TMI DOCUMENTS

RADIOLOGICAL REF. # 50

SATISFACTORY COMPLETION OF
RADIATION EMERGENCY DRILL
ACCEPTANCE FORM

RADIATION EMERGENCY DRILL CRITIQUE
INDIVIDUAL ACTION ITEM ASSIGNMENT SHEET

MAJOR/MINOR CHANGE/MODIFICATION REQUEST FORM

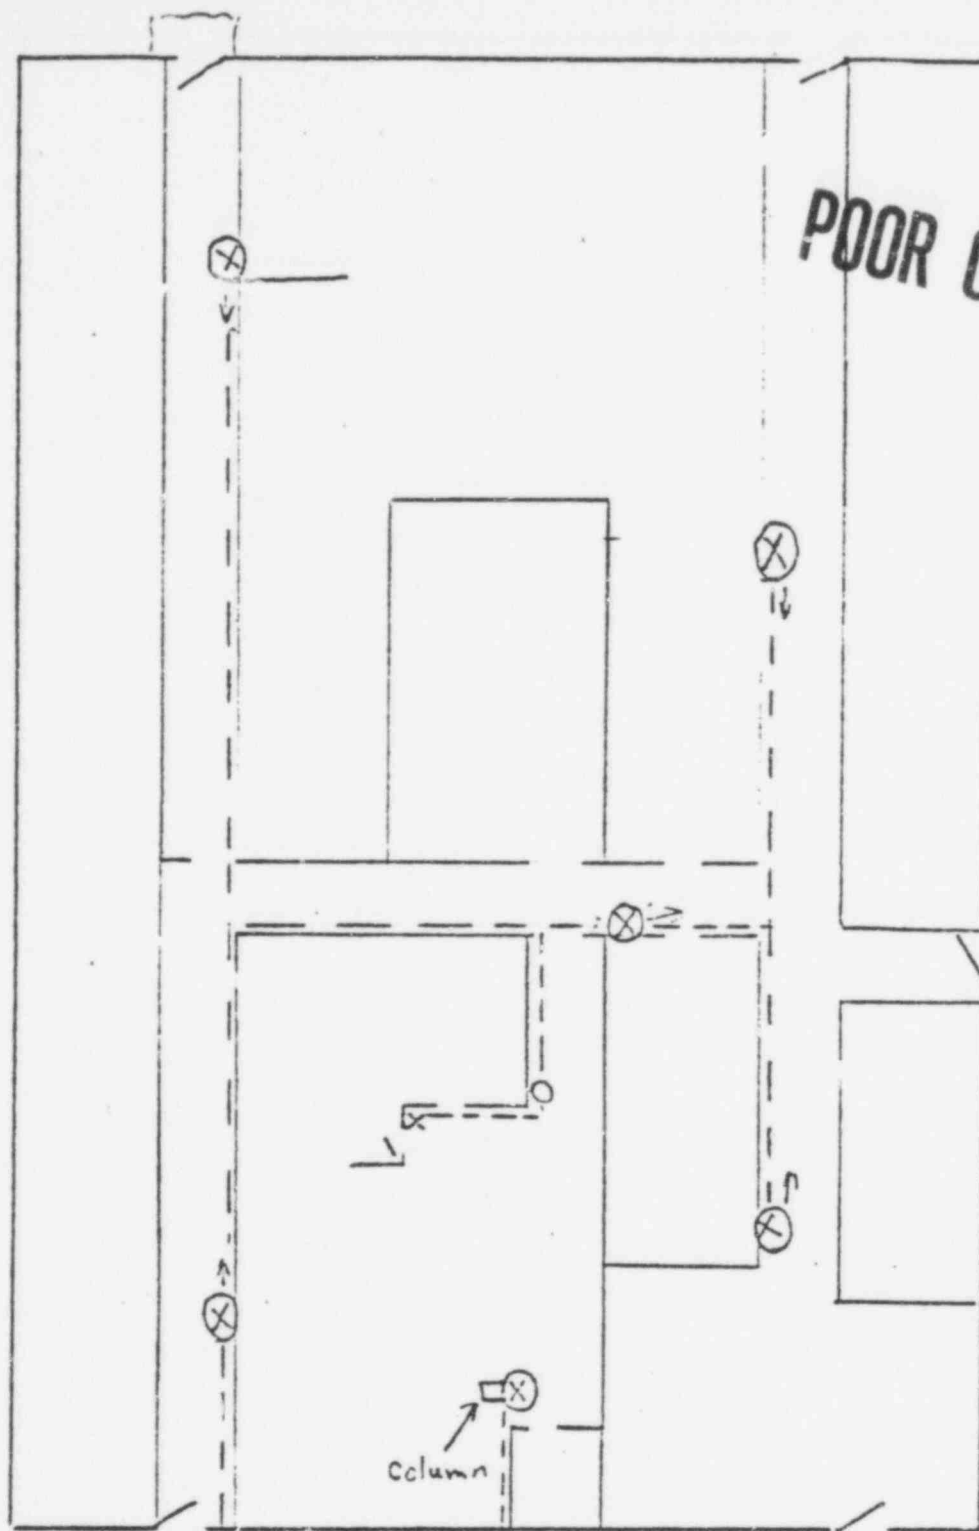
ACTION TO BE TAKEN: Need communications hardware for Green Office Building (West Side).

1. System: Communications
2. Component (name & number) GATronics System
3. Describe malfunction and cause of malfunction (if known) or modification desired.
Provide interplant GATronics communications to the personnel working in the Admin. Bldg and also to provide them notification of an emergency drill, Test or real. Rad drill action item #7

Add 6 - 5 channel GAItronics units To The system per attached drawing

To provide inter plant GAItronics communications To The personnel working in Admin Bldg. and provide them with a backup communication path.

ACTION RESOLUTION: WR 5828 CM 2-0230

The attached WR & CM were initiated To provide GAIronics
communications To The Admin Green Office Bldg
